April, 2000

Series 67 Fitting Change

Original Design (*Before October 1999 & After February 2000*)

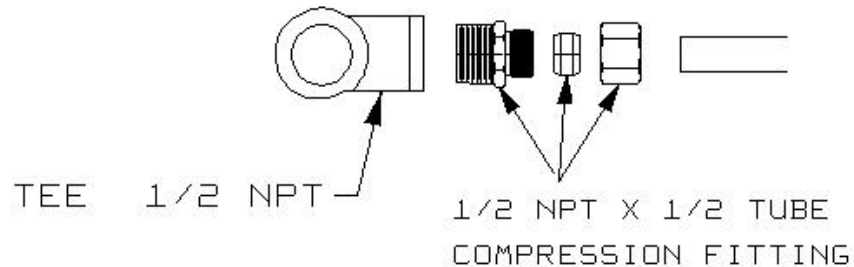
In October 1999, McDonnell & Miller changed the attachment hardware on the Series 67 Low Water Cut-Off. The change involved replacing the special compression fitting located in the upper gauge glass tapping with a standard tee and compression fitting. The graphic below shows an exploded drawing of the current design, and another of the change.

The intent of this change was to standardize components on the production floor thus further improving our on-time shipping ability. However, we received several complaints from OEMs and contractors in the field that the change has made installation difficult. As a result, **we reverted back to the original design at the end of February 2000.**

Replacement tube assemblies SA66-35 (344100) reflecting the original design are available. Call your Customer Service Representative or Steve Mueller if your customers need "original design" tube assemblies. We will provide them at no charge.
